## HPZ 2020-008 - 2928 North Beverly

### Discussion of alternative window trim details at replacement and new windows

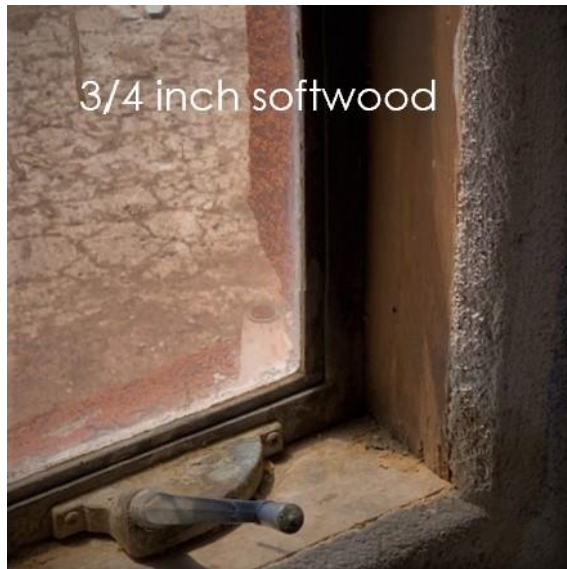
The TPCHC Plans Review Subcommittee requested applicant explore window trim details to distinguish between replacement/modified windows (as at West elevation) and new window openings in existing walls to distinguish them from existing fenestration.

Applicant's current design is based on residential steel casement windows, for reasons of compatibility with subject property and adjacent contributing dwelling approved by this subcommittee in HPZ 04-13, and compliance with "Fort Lowell Historic Preservation Zone Design Review Guidelines."

Both dwellings, HPZ 2020-8 and HPZ 04-16 are frame buildings with stucco exterior and lime or gypsum plaster on lath interior wall finishes. They are not high-style buildings, and many of the opening details are vernacular in nature more than representative of a specific style. Please review attached photographs and sketch details for the prevailing details and proposed options.

Typical window opening details show the window at or near the middle of the wall thickness, with stucco wrapping back into opening to face of window at head, jamb and sill, and ¾ inch softwood at interior face of window at head, jamb and sill.
